# 1989 - 1990 Corvette: Service Bulletin: Convertible: Mounting Bracket Rattle at Rear of Hardtop

**Number:** 90-203-10

**Subject:** Mounting Bracket Rattle at Rear of Hardtop

**Model Year:** 1989-1990 Y Car Convertible

**CORVETTE HARDTOP**  
**BRACKET REAR PIN MOUNTING R / L**  
 ( SERVICE PROCEDURE )

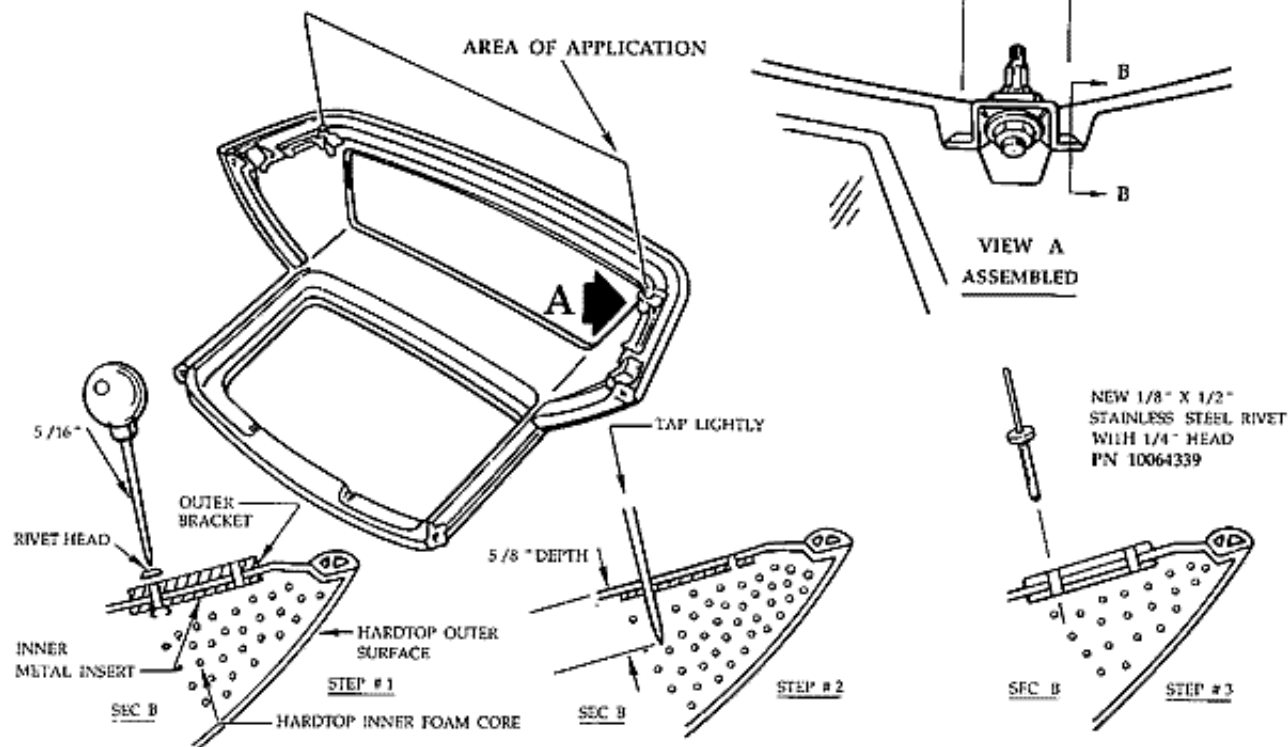
Some 1989 and early 1990 Chevrolet Corvettes (before VIN 106253) equipped with the convertible hardtop option (CC2) may exhibit a rattle at the rear of the hardtop caused by loose hardtop mounting brackets.

Some of these brackets were mounted with rivets which were not long enough to provide enough retention to prevent the rattle.

- STEP #1 DRILL OFF RIVET HEADS, USING A 5/16" DRILL BIT, AND REMOVE BRACKET. (4 RIVETS PER ASM.)
- STEP #2 TAP PREVIOUS RIVET BODIES AND MANDREL 5/8" DOWN INTO HARDTOP INNER FOAM CORE AREA. (4 RIVETS)
- STEP #3 REPOSITION BRACKET AND RE-ATTACH USING NEW RIVET (PN 10064339)
